STATE OF MAINE
DEPARTMENT OF TRANSPORTATION
16 STATE HOUSE STATION
AUGUSTA, MAINE
04333-0016

May 11, 2007
Subject: **Brewer**
Project Number: FBD-9840(100)X
PIN: 9840.10
Amendment No. 2

Please make the following changes to the Bid Documents:

SHEET PILE
STA. 38+58 TO STA. 41+00
 SCALE: 1"=40'

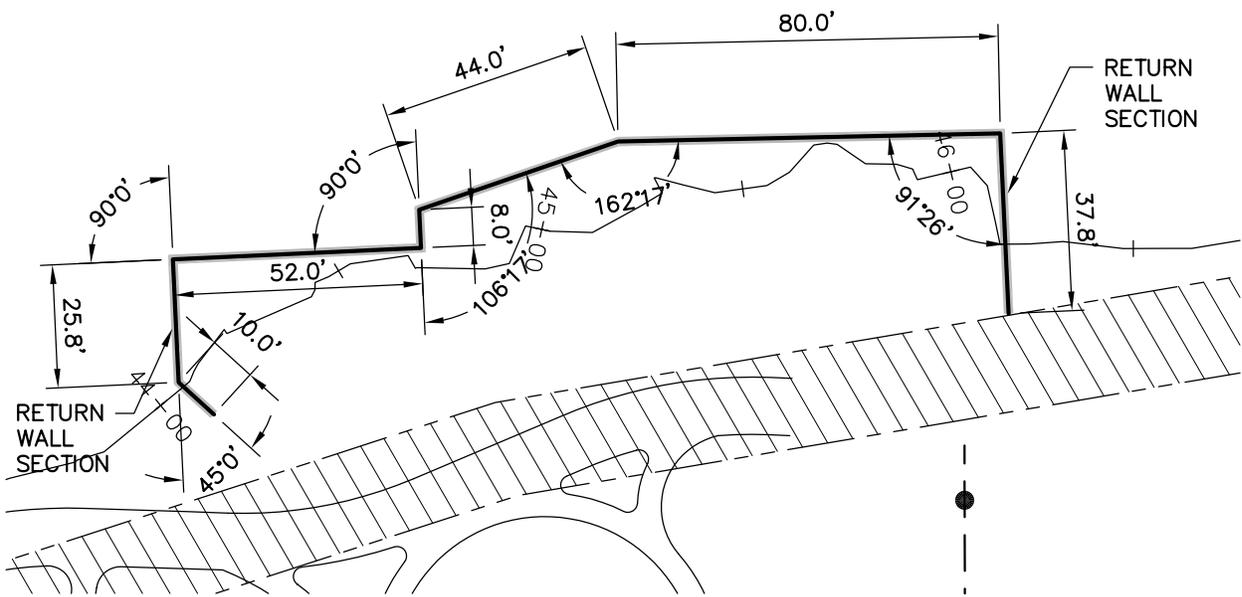
Question: The layout of the Sheet Piling Bulkhead Walls is not dimensioned well. Is a better dimensioned drawing available? Is the layout similar to the Guardrail Plan on Plan sheet C-10?

Response: *Please see enclosed Detail sheet labeled Sheet Pile Dimensions, Figure 1 for additional dimensions.*

SHEET PILE RETURN WALL SECTION
STA. 38+58 TO STA. 41+00

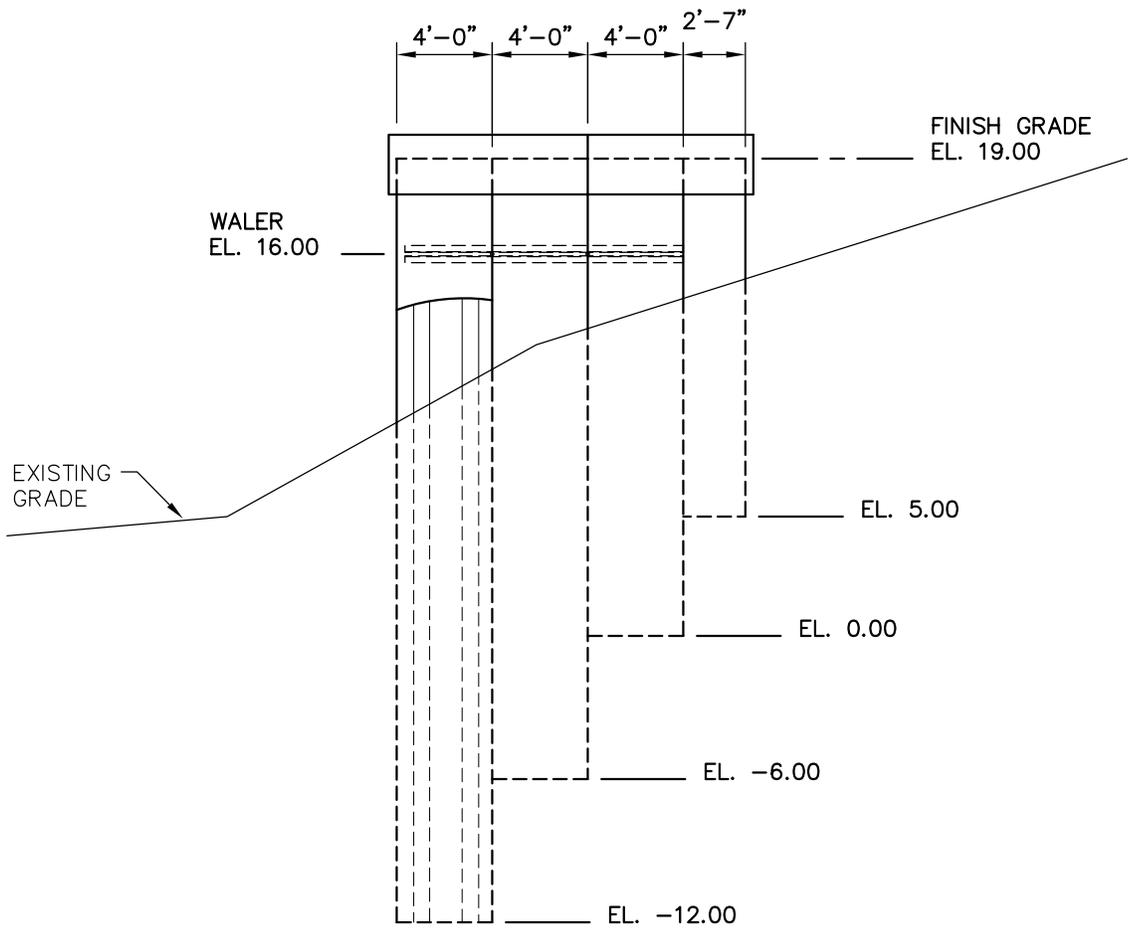
Question: Plan Sheet C-06 has a Return Wall Detail. Where is this wall located?

Response: *See Detail sheets included in this addendum labeled Sheet Pile Return Wall Section Station 44+07 to Station 46+25, Figure 3 for location and enclosed sheet labeled Sheet Pile Return Wall Section Station 38+58 to Station 41+00, Figure 2 for clarification.*
